12/19/22

Stone Bank Condos Possible compliance issues

Applicant responses 12/21/22

Staff responses 12/28/22

Plan of Land in Tisbury, Mass.
Prepared For
Old Stone Bank Condominium
Scale: 1" = 20' December 6, 2021
Schofield, Barbini & Hoehn Inc.
Land Surveying & Civil Engineering
12 Surveyor's Lane, Box 339
Vineyard Haven, Mass. 02568
508-693-2781
www.sbhinc.net
MV 4338
Sheet 1 OF 3

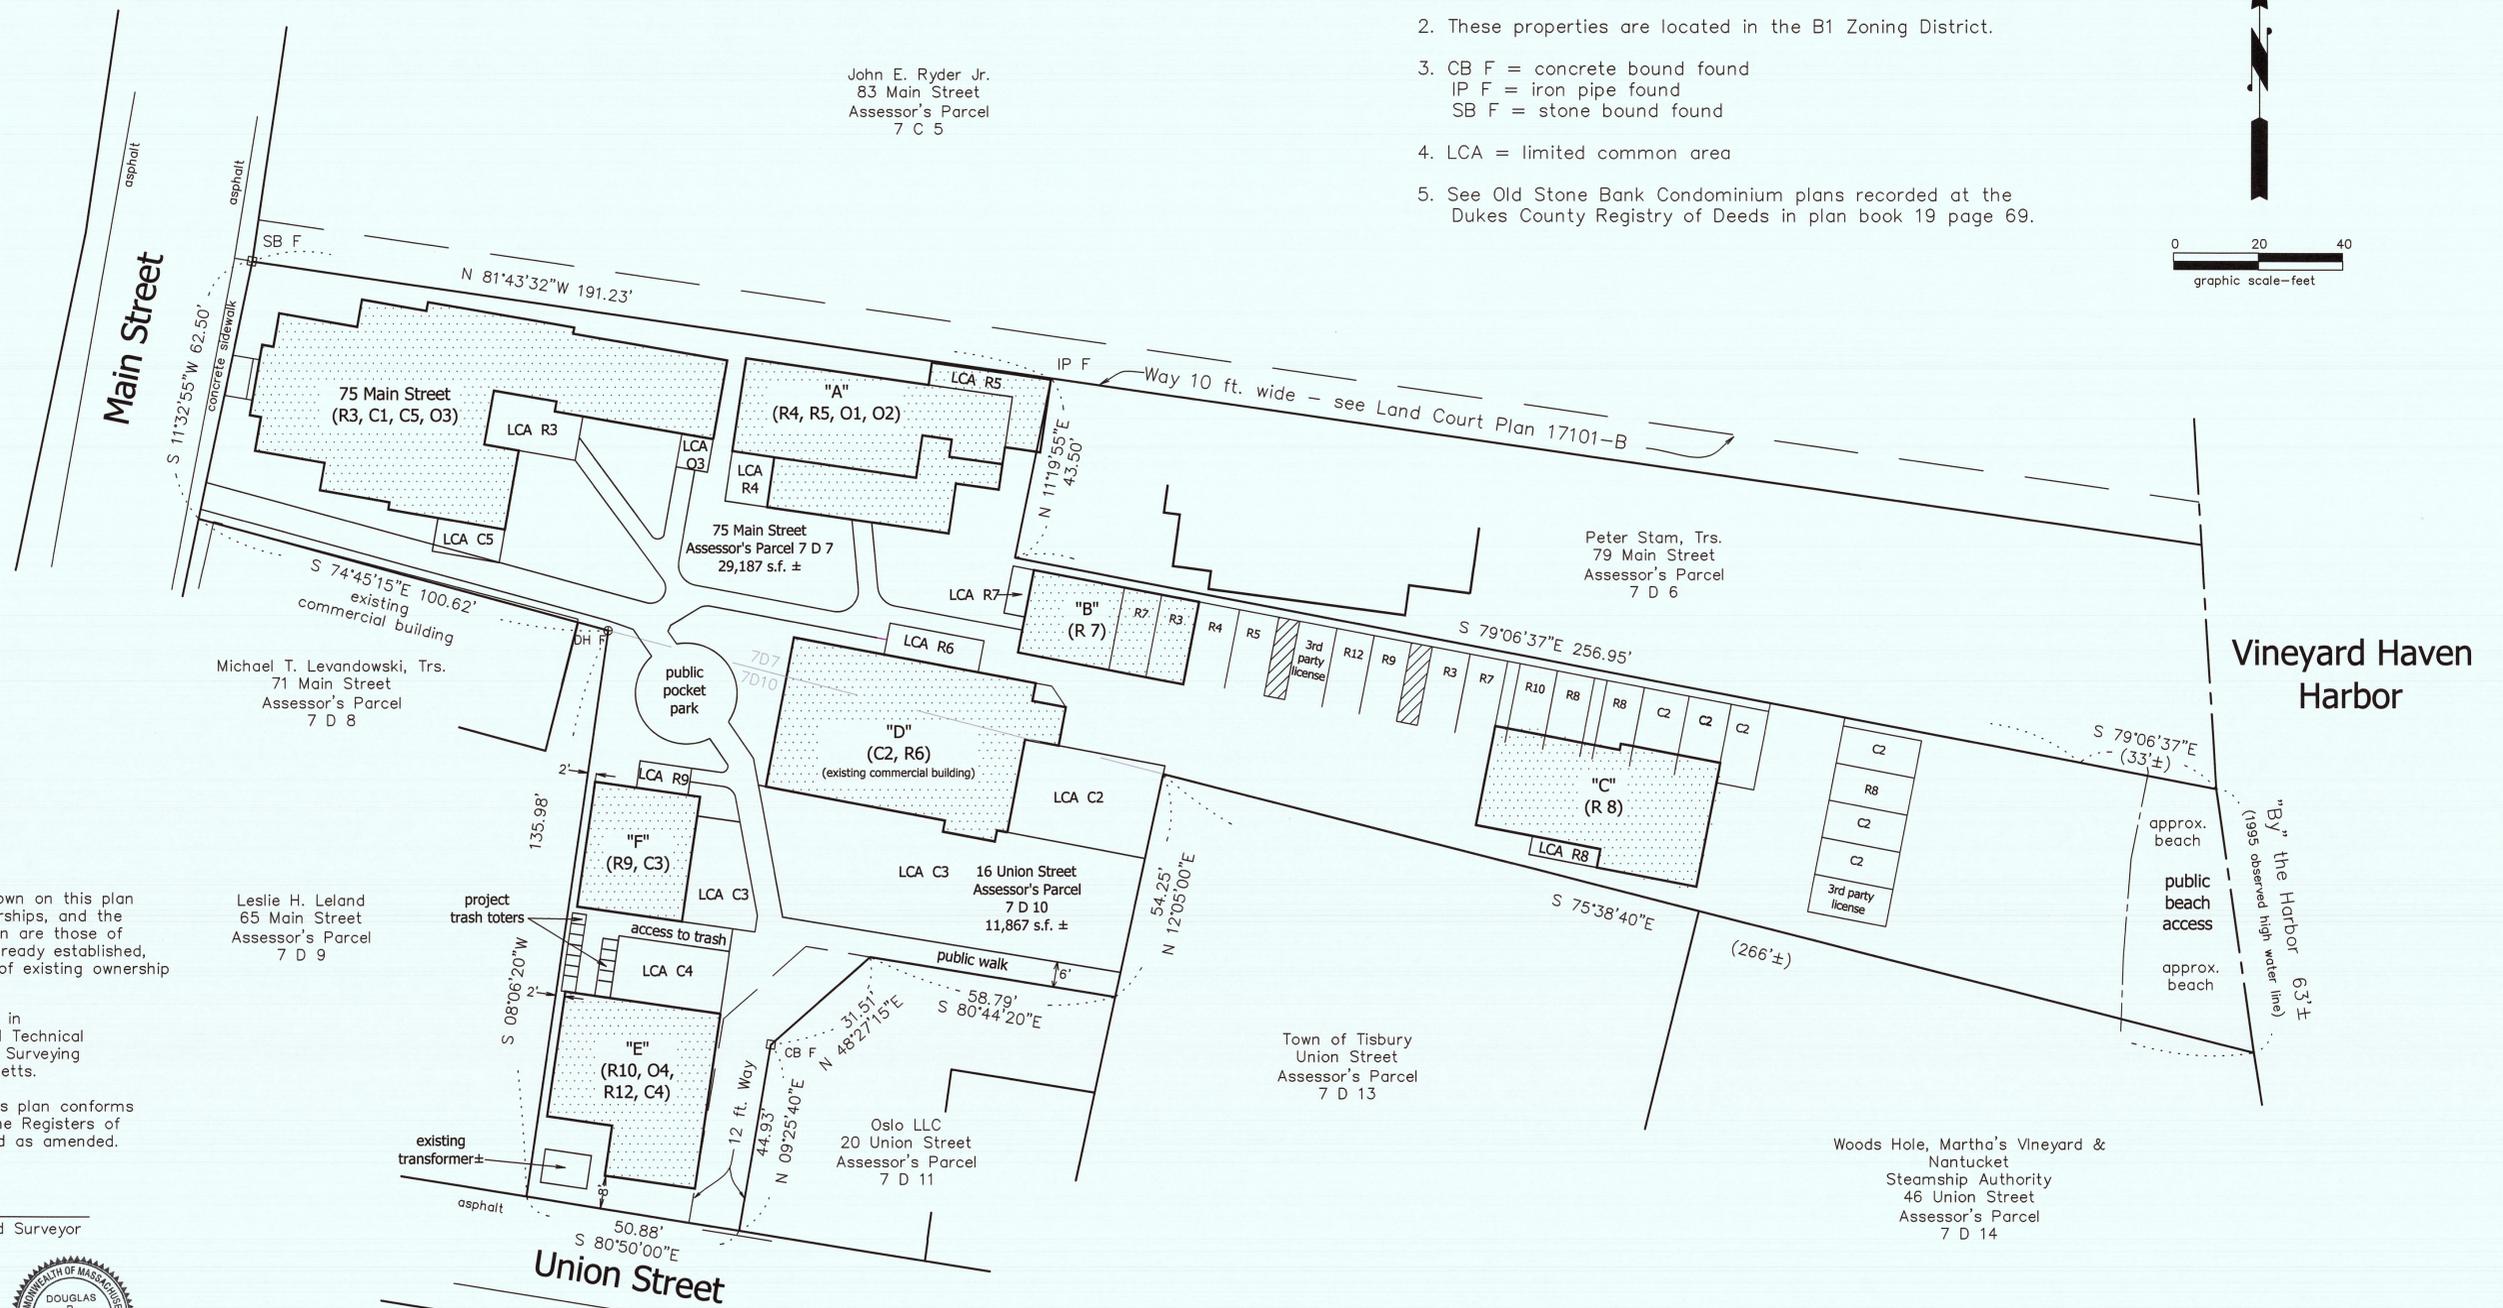
2. The approved site plans were not all drawn to scale. However, buildings E and F appear to be closer to Union Street than represented in the plans.

Please clarify.

They may appear to be closer but this is because the sidewalk on Union Street is actually on Stone Bank property.

Please see the attached stamped and signed condominium site plan. This accurately shows the as-built locations of the buildings. The Union Street sidewalk is on the Stone Bank property.
